Work Order ID 107276

Item Name: Cable Ass'Y

DART SERVICE INSTRUCTION

TO AMEND IIN-D412-704 REV. C OR EARLIER
AND ICA-D412-704 REV. 4 OR EARLIER
REF CANADIAN STC SH93-34
REF FAA STC SR00957NY
REF EASA STC EASA.IM.R.00696

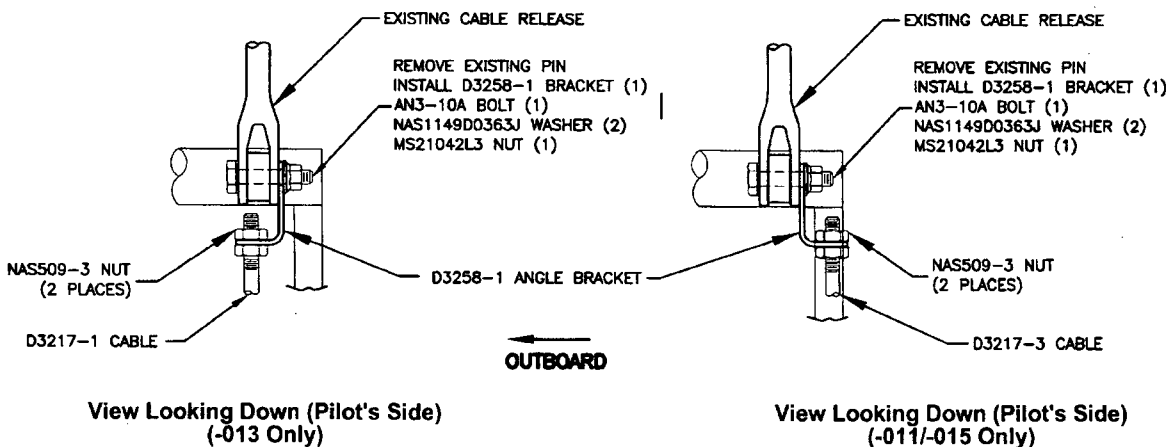
PART LIST CORRECTION

Revise Part Lists in IIN-D412-704 & ICA-D412-704 as follows:

Figure 5 - Detail L or Figure 25-4 - Detail L

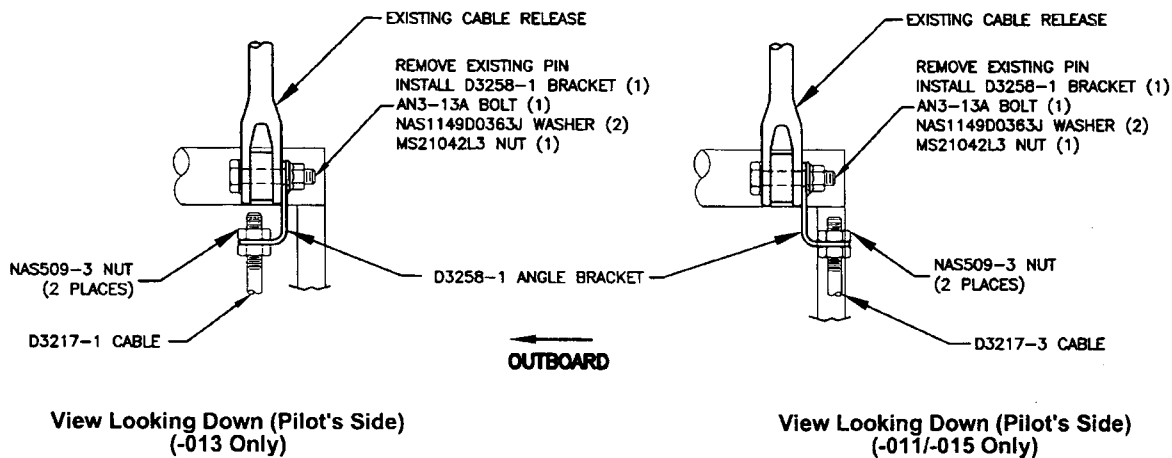
The purpose of this Dart Service Instruction is to correct part number error in Installations Instruction IIN-D412-704 Rev. C or earlier and Instructions for Continued Airworthiness ICA-D412-704 Rev. 4 or earlier. The AN3-13A bolt should be replaced with an AN3-10A bolt in Figure 5 - Detail L in IIN-D412-704 and Figure 25-4 Detail L in ICA-D412-704. See sheet 2.

FIGURES CORRECTION

Revise Detail L Figure 5 of IIN-D412-704 and Detail L Figure 25-4 of ICA-D412-704 as follows:
